RE: Agreement No. 2139S
Traffic Impact Study Services
Task No. 1A Subtask 17 – 7-Eleven - 4016 N. Dupont Highway

McCormick Taylor has completed its review of the Traffic Impact Study (TIS) for the 7-Eleven - 4016 N. Dupont Highway development prepared by Traffic Concepts, Inc., dated February 6, 2026. Traffic Concepts prepared the report in a manner generally consistent with DelDOT's Development Coordination Manual.

Scope of Improvements Figure 7-Eleven - 4016 N. Dupont Hwy TIS

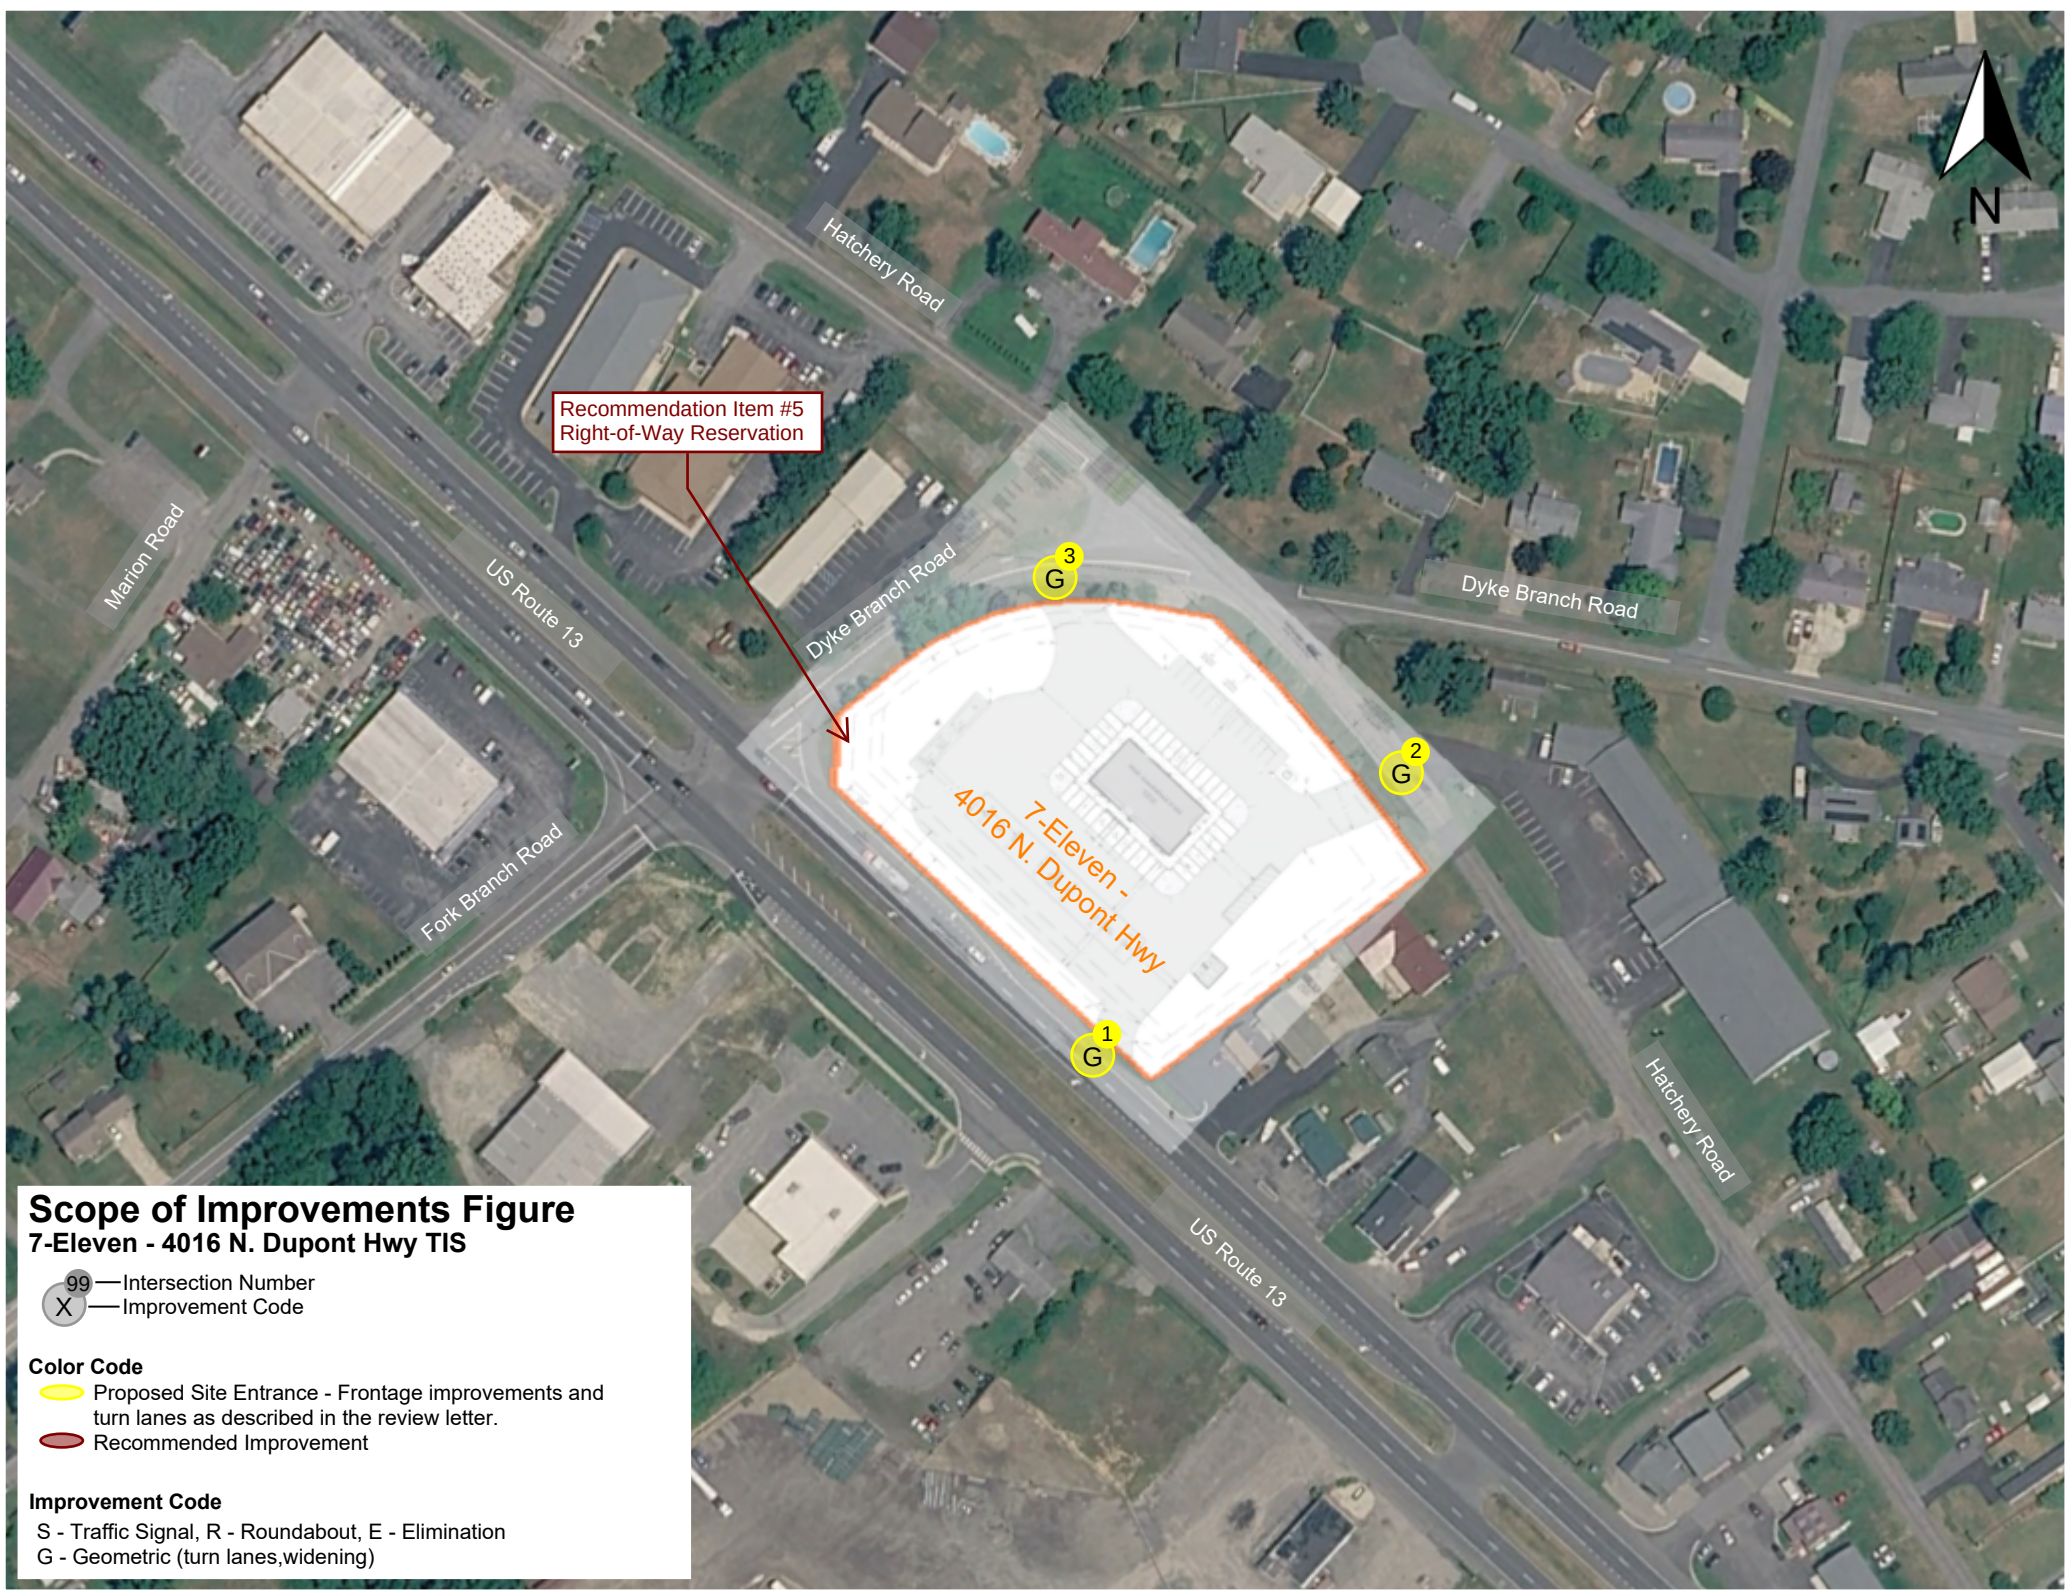
The intersection of Site Entrance A and US Route 13 is proposed on the east side of US Route 13, approximately 350 feet south of Dyke Branch Road with right-in only access. The proposed entrance replaces an existing driveway with right-in/right-out access located approximately 300 feet south of Dyke Branch Road. The recommended right turn lane will extend beyond the limits of the proposed development's frontage on US Route 13. The developer should coordinate the design and construction of this turn lane with adjacent property owners and DelDOT's Development Coordination Section.

- The developer should construct the right-in Site Entrance A on US Route 13, approximately 350 feet south of Dyke Branch Road. The proposed configuration is shown in the table below.

3. The developer should construct the full-movement Site Entrance B on Hatchery Road, opposite the north entrance to the Alliance Material Handling facility. The proposed configuration is shown in the table below.

4. The developer should construct the full-movement Site Entrance C on Dyke Branch Road, approximately 100 feet west of Hatchery Road. The proposed configuration is shown in the table below.

5. The developer should enter into an agreement with DelDOT for a right-of-way reservation at the intersection of US Route 13 and Dyke Branch Road to allow for potential future traffic signal improvements. The developer should coordinate with DelDOT's Traffic and Development Coordination Sections to determine the limits of the right of way needs and other design details during the site plan review.
